**TOWN OF WINTER PARK
PLANNING COMMISSION**
Tuesday, June 11, 2024 8:00 AM

TO Planning Commission
FROM James Shockey, Community Development Director
DATE June 11, 2024
RE Minor Site Plan Lots 1-5, Block 9, Roam Filing No. 1

Wilds360 Phase II Minor Site Plan Application Narrative

SITE PLAN

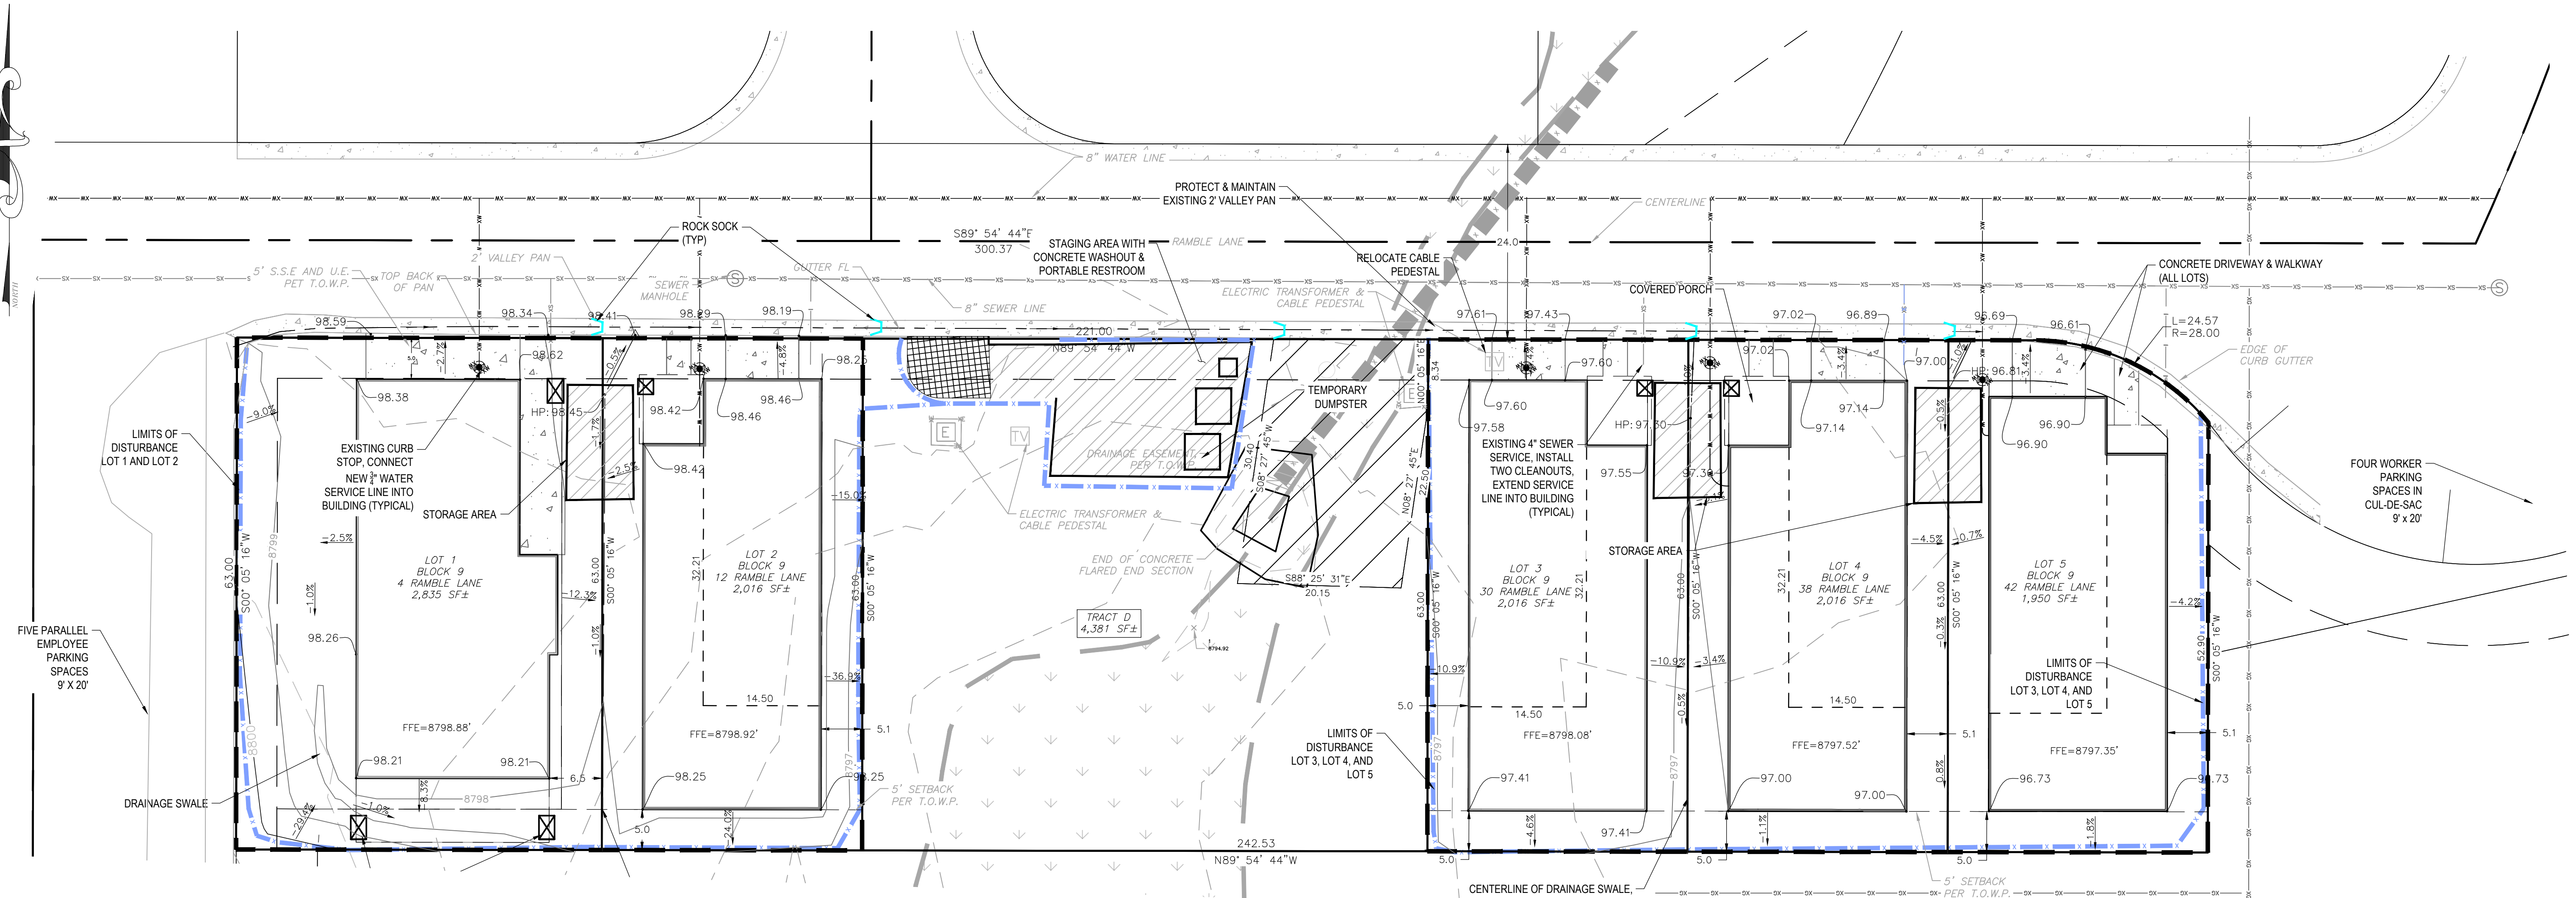
2. Lot 1 - The Site Plan indicates a drainage swale is located on the southern portion of Lot 1. The drainage swale appears to go through a proposed column that supports the rear covered porch.

- The applicant needs to provide a site dimensional table with setbacks, building footprint (SF) (including, decks, porches, balconies, and patios); drives, and parking areas; the site’s total acreage; and percentage of building coverage to open space.

1. Lot 2- The column and portions of the front porch encroaches into the side yard setback. A setback reduction is permitted up to three feet according to UDC Table 3-A-7.
 2. Lot 3- The column and portions of the front porch encroaches into the side yard setback. A setback reduction is permitted up to three feet according to UDC Table 3-A-7.
 3. Lot 4- The column and portions of the front porch encroaches into the side yard setback. A setback reduction is permitted up to three feet according to UDC Table 3-A-7.
- The applicant shall indicate on the Site Plan for Lot 2-4, the side setback measurement to the column and overhang of the front porch.

Unsatisfactory. UDC 3-H-5 requires that a minimum of 25% of all driving surfaces, including gravel shoulders, parking areas, and pedestrian walkways is designated for snow storage. The site plan labels proposed snow storage locations but does not provide any tabulation that verifies it complies with UDC standards.

- The applicant shall remove the proposed staging area from the Site Plan and provide another

- The applicant shall indicate how the proposed swale will interact with the column or otherwise redesign the floor plan or vegetative swale so that they do not intersect. ‘

3. The applicant needs to provide a site dimensional table on each Site Plan with setbacks, building footprint (SF) (including, decks, porches, balconies, and patios); drives, and parking areas; the site's total acreage; and percentage of building coverage to open space.

4. The applicant shall indicate how the proposed swale will interact with the column or otherwise redesign the floor plan or vegetative swale so that they do not intersect.

7. The applicant shall redesign covered porch on Lot 1 so that it does not encroach more than 3-feet into the 5-foot setback requirement.
8. The applicant shall indicate on the Site Plan for Lot 2-4, the side setback measurement to the column and overhang of the front porch.

11. Applicant shall provide a snow storage table that complies with UDC 3-H-5 snow storage requirements.
12. The applicant shall confirm that no structures, including temporary structures, will be located within the 30-foot required water quality setback.

13. The applicant shall remove the proposed staging area from the Site Plan and provide another location
14. No site clearing shall be permitted until the Building Division has verified the Pre-Disturbance Checklist has been implemented on the site.

LANDSCAPE PLAN

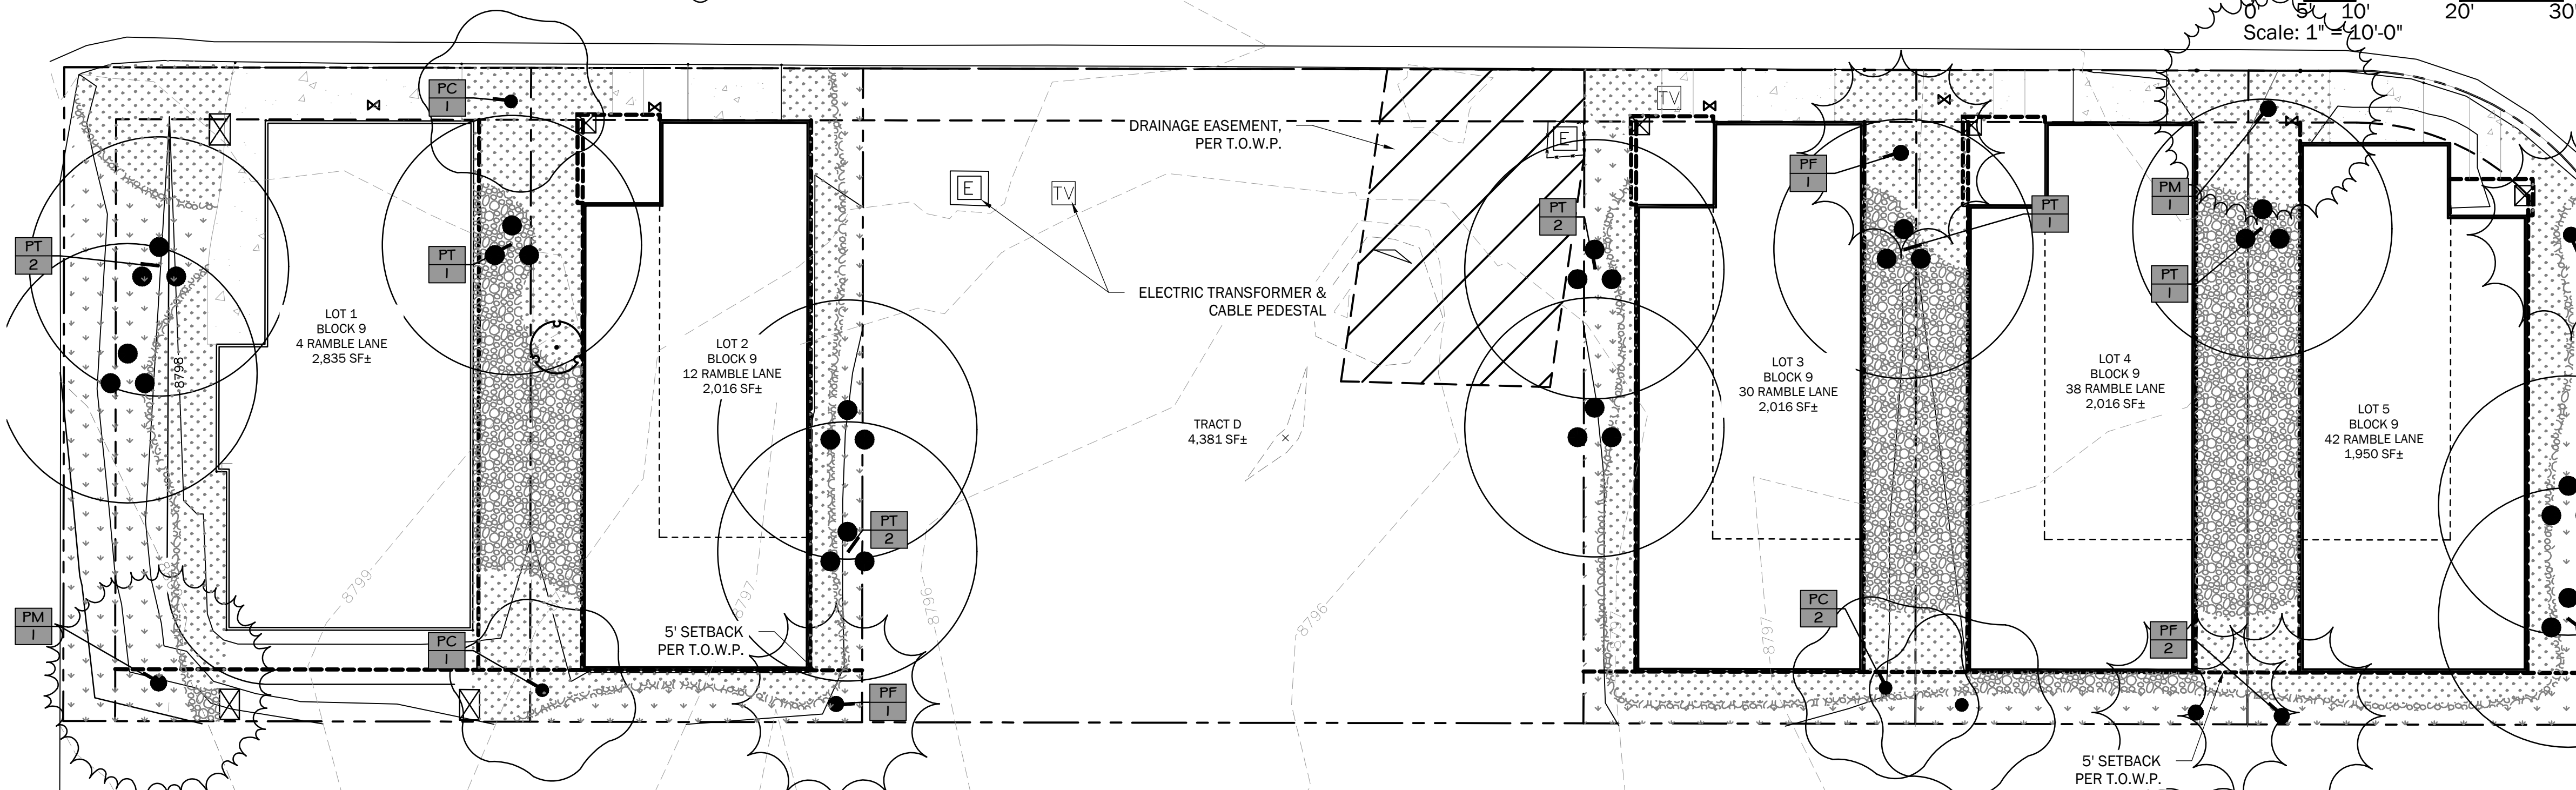
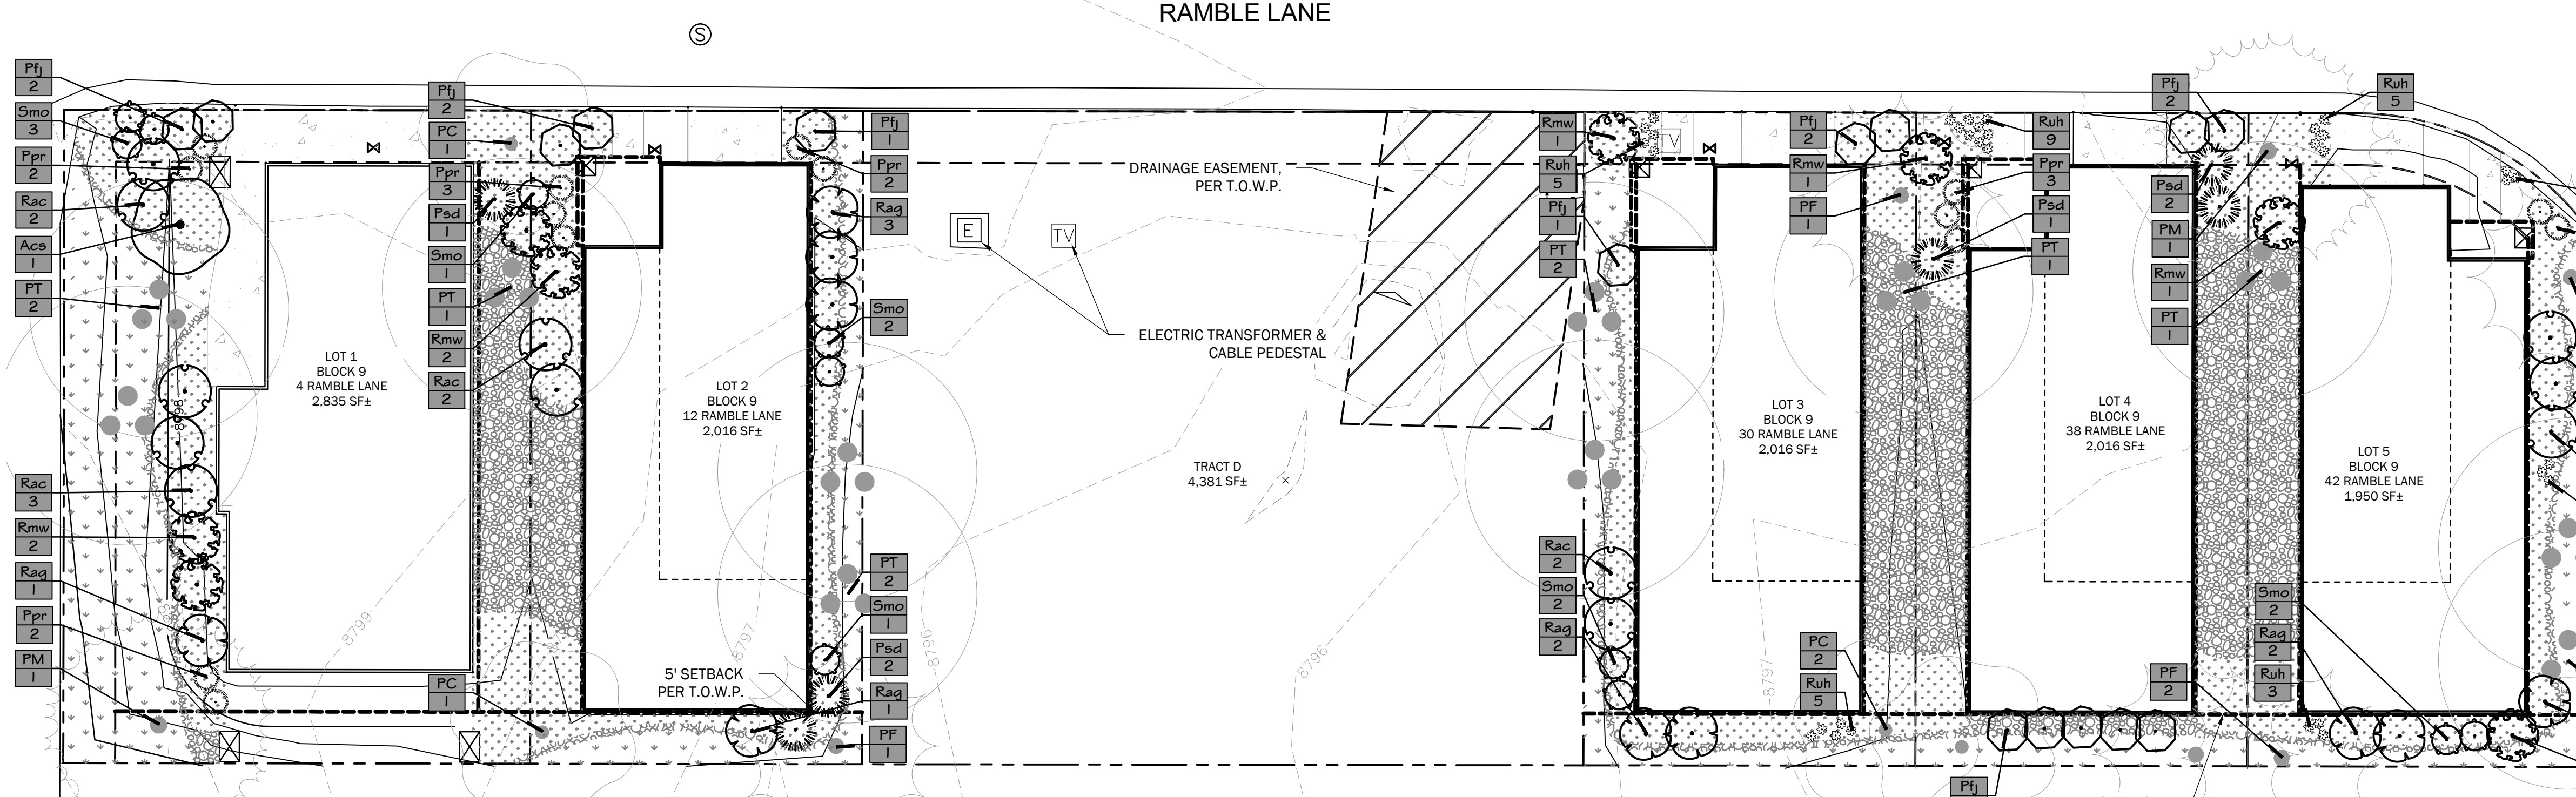
Unsatisfactory. This property is not subject Land Use Transition Zones but shall otherwise comply with the Roam FDP, Section H, Landscape and Snow Storage Guidelines, which requires lots in Roam to follow the Town of Winter Park Landscape Design Regulations and Guidelines. There are two proposed trees that are not located on the recommended plant list in the Town of Winter Park Landscape Design

- The proposed Canada Red Cherry and Douglas Fir are not the included on the recommended plant list for the Winter Park Landscape Design Regulations. Applicant shall provide justification from a qualified design professional for use of the two tree species.

9. The applicant shall adjust the starting point of the elevation on all Elevation Plans to comply with the UDC Building Height standards.
10. Applicant shall update the landscape requirement table so that the two aforementioned species are not included in the "Provided" section of the table.
